Parliamentary Paper No. 183/1983

JOINT COMMITTEE ON THE AUSTRALIAN CAPITAL TERRITORY

Report on Proposals for Variations of the Plan of the Layout of the City of Canberra and its Environs

(Seventy-eighth Series - Second Report)

COMMONWEALTH AVENUE EXTENSION-PARKES

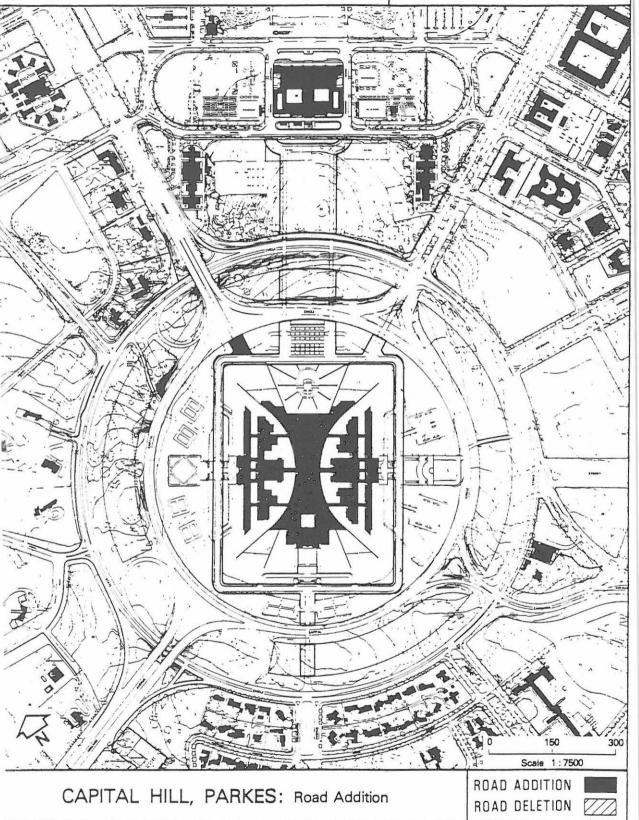
- 7. The question as to whether these ramps, particularly the ramp from Commonwealth Avenue, are really necessary and how much each will cost must be asked. They will certainly detract from the civic design quality of the avenues and be vastly expensive.

- 8. The main approach to Parliament House as provided by the proposed 'land bridge', an expensive but necessary connection, will be markedly more dignified and more than adequate to meet all likely traffic movements to and from the forecourt of Parliament House. There appears to be no reason why this main approach could not be used for access from the avenues rather than the 'bee-line' taken by the proposed ramps, especially the clumsy arrangement intended to provide access from Commonwealth Avenue.

The Committee approves the extensions to Commonwealth and Kings Avenues, provided that the visual impact of the rising road ways is minimised. The ramps should be harmonised with their surroundings by having a contoured and undulating landform supporting the ramp, complemented by an appropriate level of plantings and concealed parapet lighting instead of overhead lighting.

- 32. The Committee believes that by providing an undulating earth form on which part of the ramp sits, with plantings to further soften its appearance, the circular perimeter will remain visible, without the ramp being the imposition on the landscape that it was in the form first proposed. The ramps should have parapet, rather than overhead, lighting to minimise their visual height.

KINGS AVENUE EXTENSION - PARKES

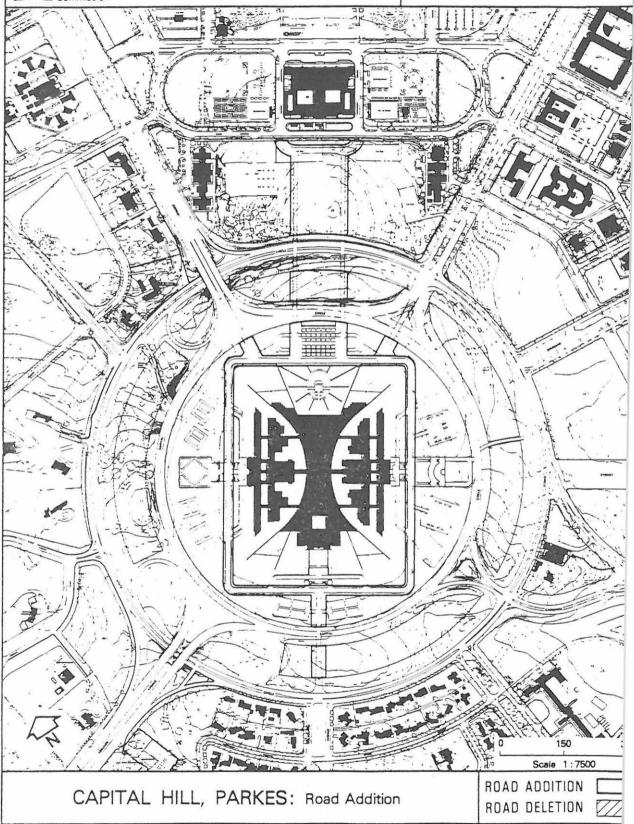
- 20. The difficulties with the ramps encountered by the Committee in the previous Parliament are primarily those associated with Commonwealth Avenue. The Kings Avenue ramp, unlike the Commonwealth one, fits into the landscape but would create symmetry problems if built without the Commonwealth ramp.

The variation will permit a change in the operation of the Kings Avenue/State Circle intersection to handle traffic which presently uses Kings Avenue.

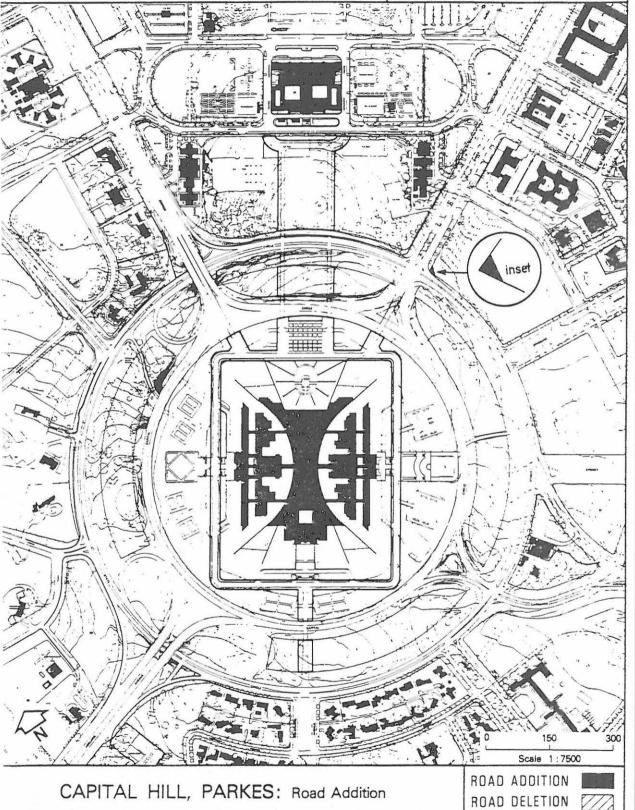
- 40. The purpose of this variation is to permit a change in the operation of the Kings Avenue/State Circle intersection to handle traffic to and from the south which presently uses Kings Avenue.
- 41. The intersection currently allows a free left turn for traffic in a single lane from Kings Avenue into State Circle travelling south.
- 42. The proposal involves the rearrangement of the intersection to allow two lanes of traffic to turn left into State Circle with direct access from Kings Avenue to Capital Circle being removed.

43. The Committee approves this variation.

CANBERRA AVENUE - STATE CIRCLE INTERSECTION DETAIL

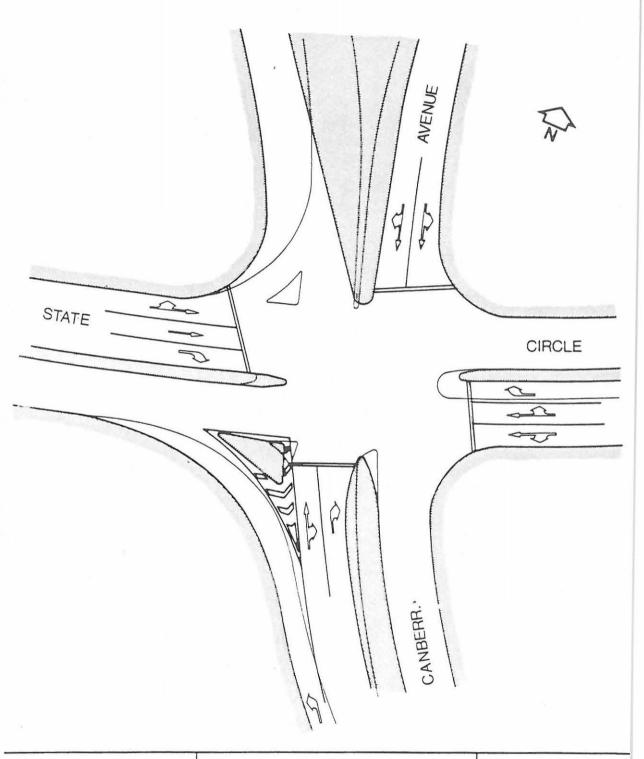
- The State Circle/Canberra Avenue Intersection is to be rearranged to provide an improved right turn facility for southbound traffic from State Circle onto Capital Circle. Two lanes will turn right, then merge, before entering Capital Circle in an exclusive lane. An additional lane is currently under construction on Capital Circle to allow this traffic from Kings Avenue and State Circle to enter Capital Circle and then Adelaide Avenue unobstructed.
- The possibility to continue on State Circle and enter Adelaide Avenue via the ramp adjacent to the Prime Minister's Lodge will remain. But by offering easier entry, the proposal is expected to contain the peak hour traffic flows at about their current level along the residential section of State Circle.
- The estimated cost of this proposed development is \$80 000.
- 47. The Committee approves this variation.
